# Access Compliance Report

## Public Rights-of-Way

Intersection ID: 52996	Main Street: TIMBERBROOK_DR	Cross Street: VICTORIA_BROOK_LN	Location: SW
ADA ID: 3A69D4C05374	Ramp Type: PerpDiag	Initial Pass/Fail: Fail	Overall Compliance: No
Severity Score: 21.25			
Codes/Mitigation Info/Possible Solution		Field Measurements/Component Compliance

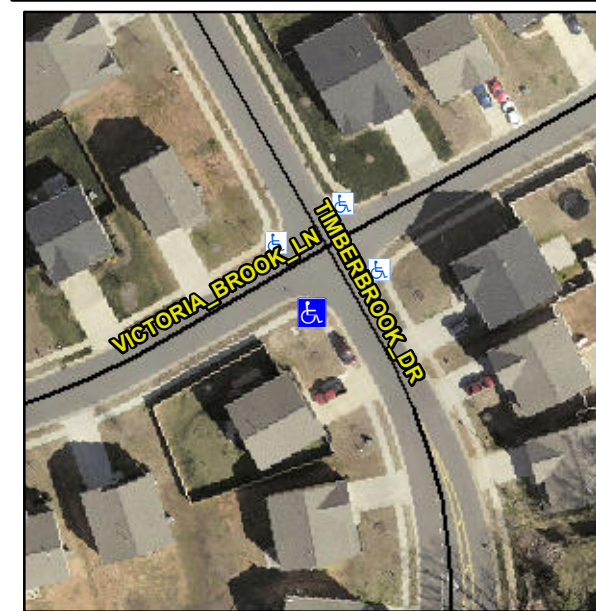
**Not Found, R304.5.1, R304.2.2**

Compliance	Description	Data	Compliance	Description	Data
N/A	Ramp Length (in)	48.0	No	Ramp Slope (%)	9.7
No	Ramp Width (in)	47.0	Yes	Ramp XSlope (%)	1.9
N/A	Flare Type LT	N/A	N/A	Flare Type RT	N/A
N/A	Flare Slope LT (%)	N/A	N/A	Flare Slope RT (%)	N/A
N/A	Flare Traversable LT?	N/A	N/A	Flare Traversable RT?	N/A
N/A	Landing Length (in)	N/A	N/A	DWS Provided?	N/A
N/A	Landing Width (in)	N/A	N/A	DWS Contrast?	N/A
N/A	Landing Slope (%)	N/A	N/A	DWS Length (in)	N/A
N/A	Landing X Slope (%)	N/A	N/A	DWS Full Width?	N/A
N/A	Landing Curb? (Y/N)	N/A	N/A	DWS Offset (in)	N/A
N/A	Shared Landing?	N/A			
N/A	Gutter Ponding?	N/A	N/A	Gutter Slope (%)	N/A
N/A	Gutter Lip Ht (in)	N/A	N/A	Gutter X Slope (%)	N/A
N/A	Painted X Walk1?	No	N/A	Painted X Walk2?	No
	X Walk 1 Direction	To E		X Walk 2 Direction	To N
N/A	X Walk 1 Width (in)	N/A	N/A	X Walk 2 Width (in)	N/A
	X Walk 1 Slope (%)	1.6		X Walk 2 Slope (%)	1.9
	X Walk 1 X Slope (%)	1.2		X Walk 2 X Slope (%)	3.8

**Remove & Replace Curb Ramp With Two New Directional Ramps or Equivalent.**
